# Service Bulletin

Bulletin No.: 23-NA-156

**Subject:** Information on M1L Automatic Transmission Production Running Changes

Brand:	Model:	Model Year:		VIN:		Engine:	Transmission:
		from	to	from	to		
Chevrolet	Corvette	2020	2024	P5137263	— —	—	8-Speed Automatic (RPO M1L)

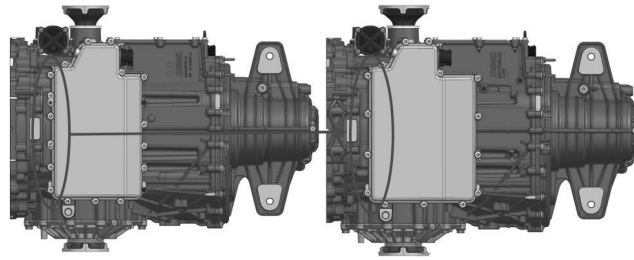
To identify a new Die3 transmission easily, the new Die3 only has 4 fasteners along the front edge of the sump pan, where the old Die2 transmission has 6 fasteners along the front edge of the sump pan. Refer to the graphic above. 6420769
